KING TECHNOLOGY INC.

CITY OF O'FALLON GENERAL NOTES

DRAWING INDEX

KEYSTONE COMPANIES
 12400 OLIVE BLVD., SUITE 565
 ST. LOUIS, MO 63141
 314-576-5200
 FAX: 314-576-6060

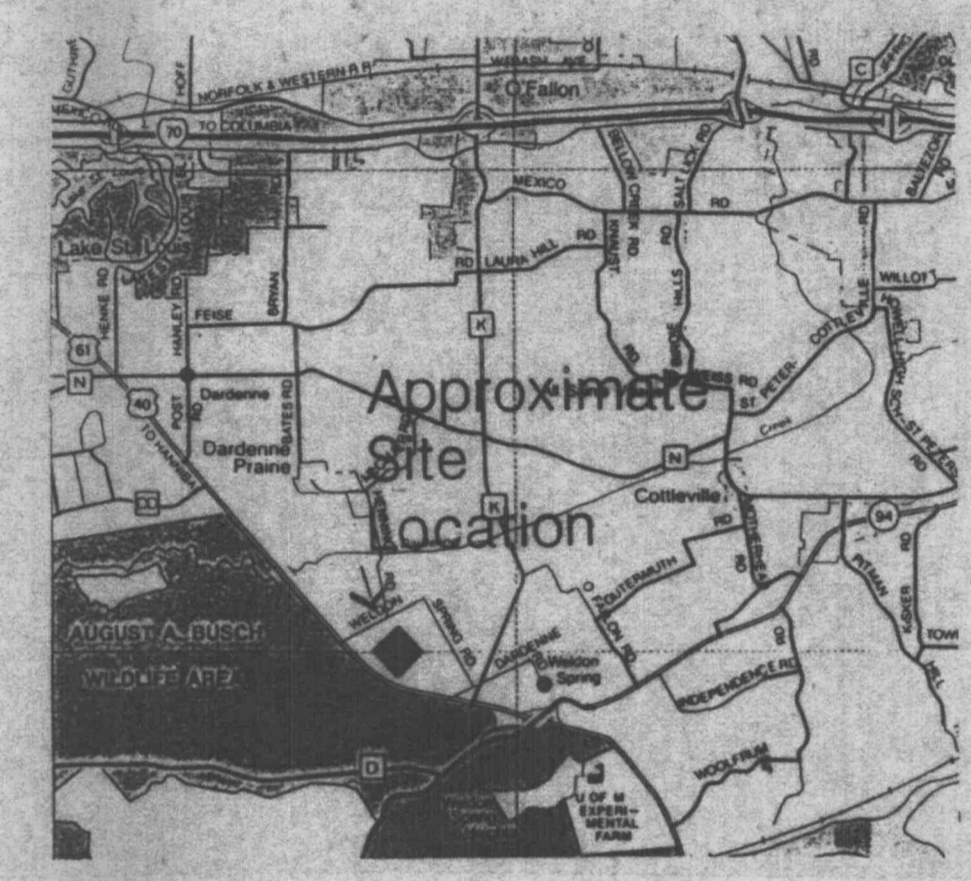
APPROVED
 Contingent on:
 1) Addressing planning comments.
 2) Construct energy dissipater @ FE 0.
 Jim King
 12-8-95
